FRANKLIN COUNTY STATE AIRPORT
SCHEMATIC SHEET

PROJ. AIR NO. 03-2029
SHEET 4 OF 11

FRANKLIN COUNTY STATE AIRPORT
AIR 03 2029
MISCELLANEOUS LIGHTING DETAILS

FRANKLIN COUNTY
 STATE AIRPORT
 DISPOSITION OF OBSTRUCTIONS

RUNWAY LIGHTING & REILS CIRCUITS

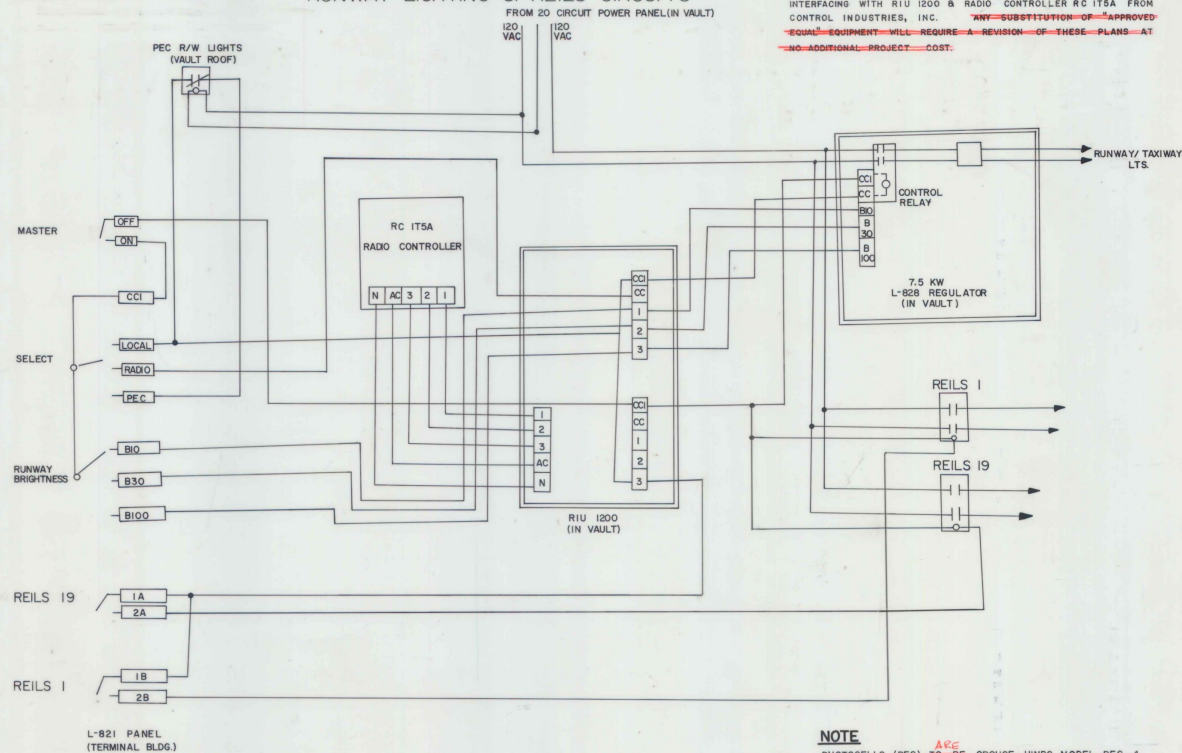
THE WIRING DIAGRAM SHOWN BELOW IS DESIGNED FOR USE WITH RADIO INTERFACING WITH RIU 1200 & RADIO CONTROLLER RC IT5A FROM CONTROL INDUSTRIES, INC. ~~ANY SUBSTITUTION OF APPROVED EQUAL EQUIPMENT WILL REQUIRE A REVISION OF THESE PLANS AT NO ADDITIONAL PROJECT COST.~~

WIND CONE-BEACON CIRCUITS

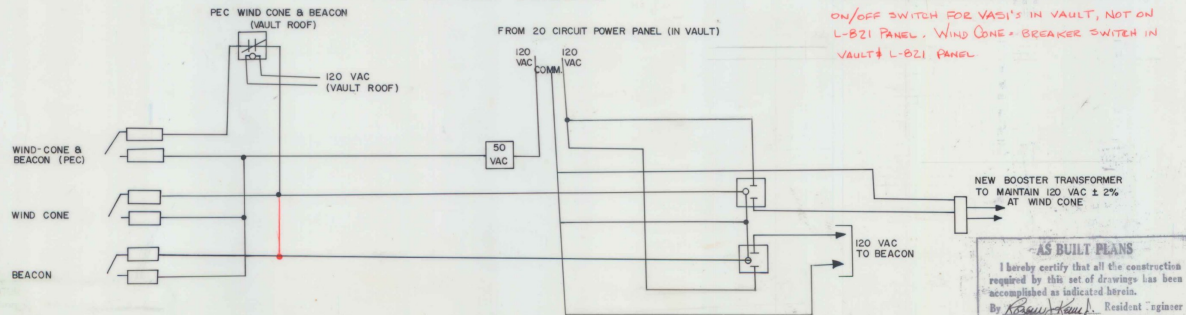
PHOTOCELLS (PEC) ^{ARE} TO BE CRUSE-HINDS MODEL PEC-4 OR AN APPROVED EQUAL. BOTH TO BE MOUNTED ON NORTH WALL OF VAULT (EXTERIOR) APPROX. 8' ABOVE GROUND. ON/OFF SWITCH FOR VASI'S IN VAULT, NOT ON L-821 PANEL. WIND CONE - BREAKER SWITCH IN VAULT & L-821 PANEL

DETAIL G
TYPICAL REILS LAYOUT

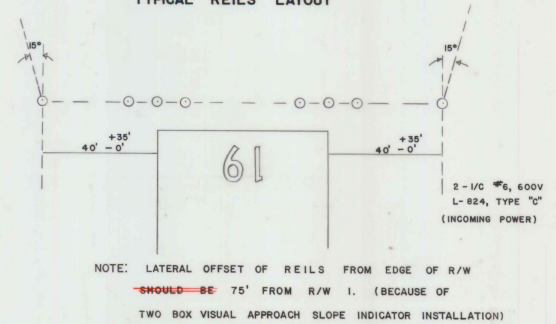
NOTE: LATERAL OFFSET OF REILS FROM EDGE OF R/W
~~SHOULD BE~~ 75' FROM R/W I. (BECAUSE OF
TWO BOX VISUAL APPROACH SLOPE INDICATOR INSTALLATION)
